COMMENTS ON BEHALF OF AUKAHA ON MINOR OR TECHNICAL (INCLUDING LEGAL) ERRORS OR OMISSIONS RECEIVED ON DRAFT REPORT AND RESPONSE

COMMENTS ON BEHALF OF ANNA HUTCHINSON FAMILY TRUST (AHFT) ON MINOR OR TECHNICAL (INCLUDING LEGAL) ERRORS OR OMISSIONS RECEIVED ON DRAFT REPORT AND RESPONSE

Te Pūtahi Ladies Mile Structure Plan - General

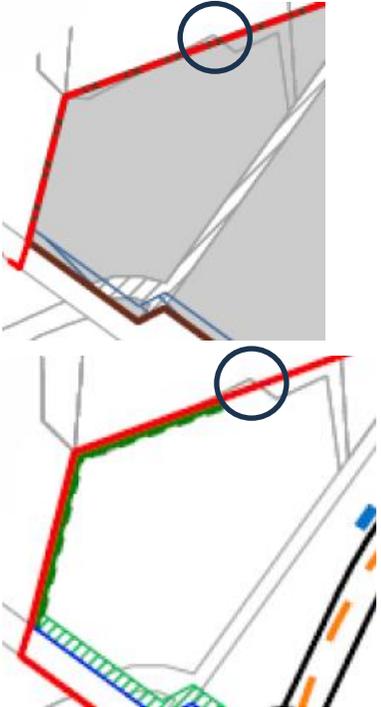
Paragraph in decision or Zone provision reference	Comment from	Comment about	Proposed change (if any)
Zoning Plan and Structure Plan on the QCC site	Queenstown Country Club	The BRA shown on the in the draft decision is supported. However, the BRA shown on the Structure Plan issued by QLDC on 22 March does not show the BRA (10m) on the QCC sites NE corner (SH6/Howards Dr intersection)	Amend the Structure Plan to show a 10m BRA on the QCC sites NE corner (SH6/Howards Dr intersection).
Rule 7.4.11	Queenstown Country Club	Rule 7.4.11 refers to Rule 7.4.24. We think the reference should be to new rule 7.4.23A (as there is no rule 7.4.24)?	Amend rule 7.4.11 to refer to RDA rule 7.4.23A, not rule 7.4.24.
